Subject: Addendum No.1, Final Design Report

**Addendum No. 1
Casandro Wash Dam
Final Design Report**

Comments from District in Letter to CH2M HILL dated April 26, 1995

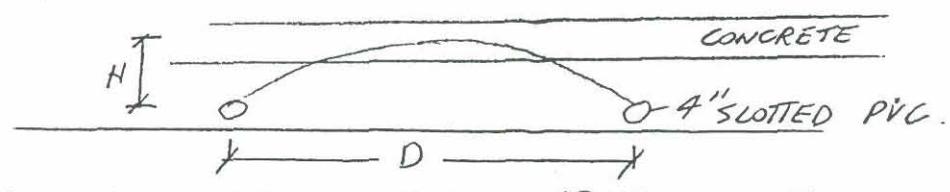
PROVIDE 2 pipes - one on each wall for redundancy
 IF HEAD BUILDS UP ABOVE OUTLET PIPE
 FLOW WILL INCREASE SIGNIFICANTLY.

PROVIDE PIPES SPACED EVENLY UNDER
 SLAB TO EQUALIZE PRESSURES.

SPACING SAY 18-20'

USING NAVFAC-DM 7.1 1982 p 278.
